### World Forum for Harmonization of Vehicle Regulations

### Working Party on Passive Safety

## Report of the Working Party on Passive Safety on its Seventy-fourth Session

Figure 1-2  
**Timeline for Dynamic, Static Time Constraint and Static Testing Representing Real Life Conditions**

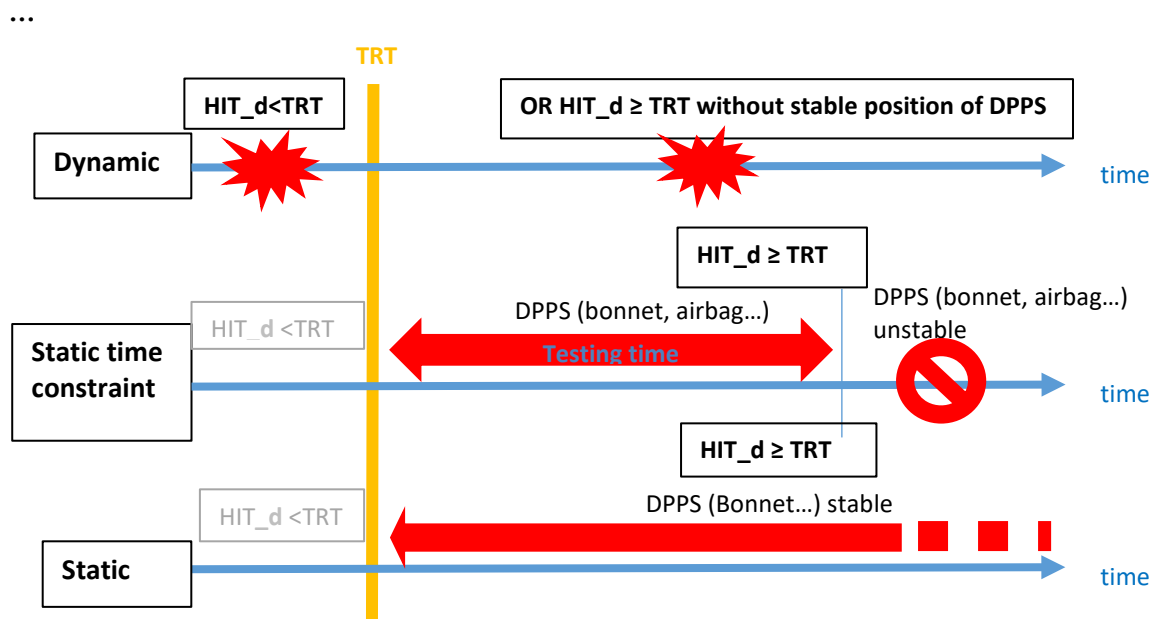
- 4.2.1.2. To enable dynamic testing to be conducted, HIT\_s **and ST** are required
- ...
- (b) ST ... **at the vehicle centreline (Y0).**
- 4.3. **"Combined" test option:**
- ...
- If ..., as in the A section in ... as in the B section in Figure 1-1, ...

Figure 1

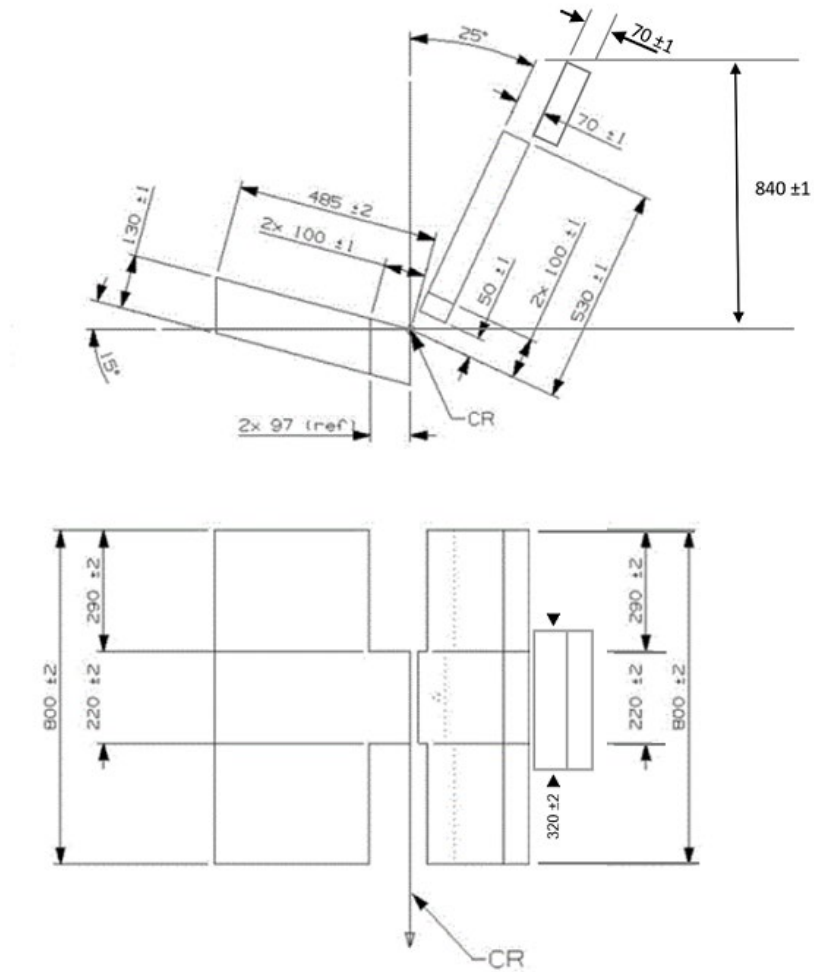
**"7.1.3.1.1.8. When testing a booster cushion in frontal impact tests on the test bench prescribed in Annex 6, an optional dummy protective device, as described in Annex 6 paragraph 3.4., may be installed on the test bench, at the decision of the technical service."**

**An optional dummy protective device may be installed on the test bench for the dynamic frontal test of booster cushion when tested on the test bench described in this Annex.**

**The dummy protective device may be covered with the Polychloropren foam of the lateral impact door as defined in Appendix 3 of this Annex, or an alternative material, at the decision of the technical service.**

**The dimensions of the dummy protective device are given in Appendix 3 of this Annex.**

**The forward face of the dummy protective device shall be parallel with the back of the backrest. The design of the dummy protective device shall be such that it does not interfere with the manikin when positioned on the test bench. Furthermore, the dummy protective device shall not interfere with the dummy and/or the adult 3-point belt during the dynamic test until the maximum horizontal head excursion has been reached.**
